DEVELOPMENT DETERMINATION PANEL MEETING

WEDNESDAY 8 AUGUST 2018

ITEM 3.1 **DA2018/0128 - 65 BOWER STREET, MANLY - DEMOLITION AND CONSTRUCTION A NEW DWELLING HOUSE**

DEVELOPMENT APPLICATION ASSESSMENT REPORT

south_elevation
65 bower street
manly

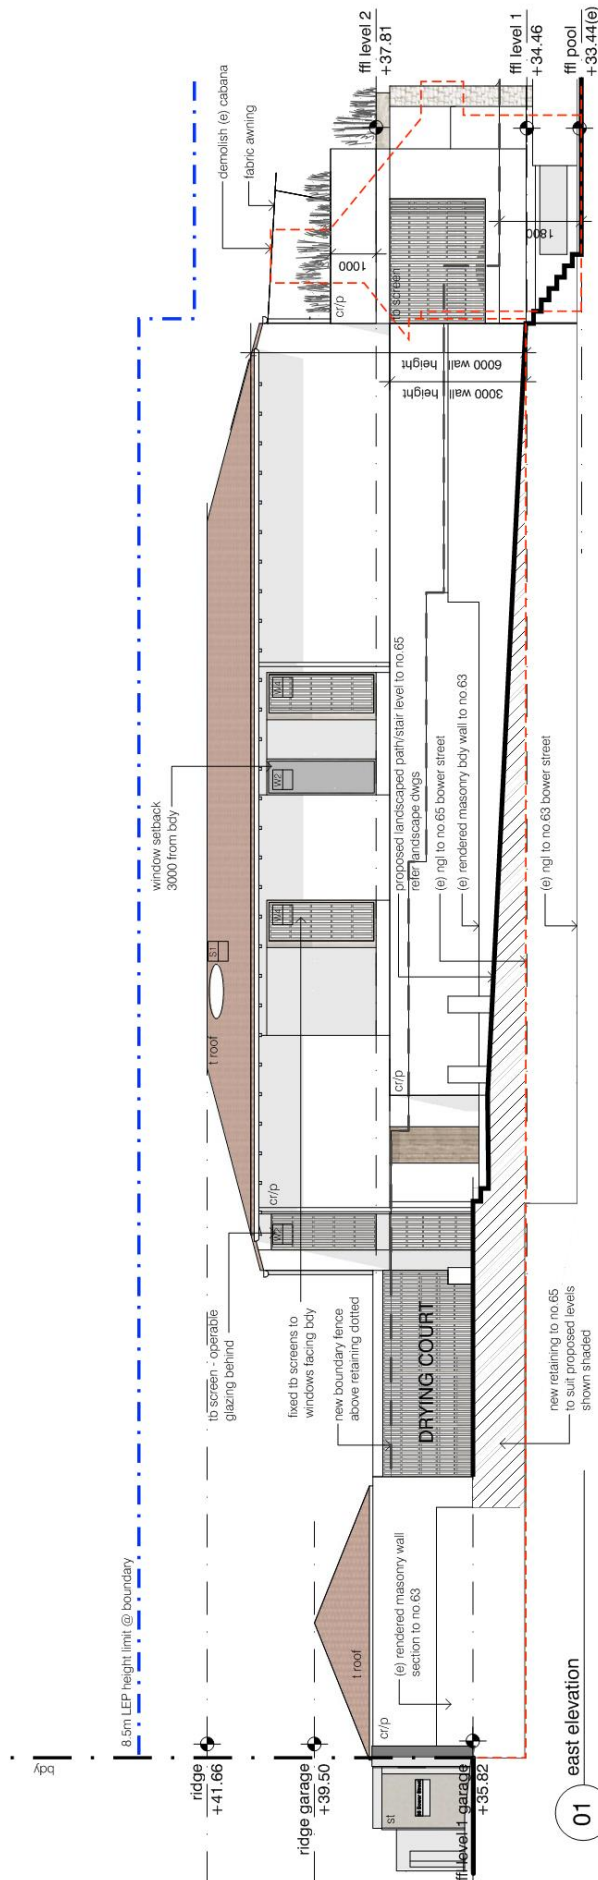
- **Clarification west elevation wall/fence. Objection to lowering of wall due to privacy impact.**
Comment:
A condition has been imposed to provide a wall that is consistent with the south elevation plan (not lowered).
DA2018/0128
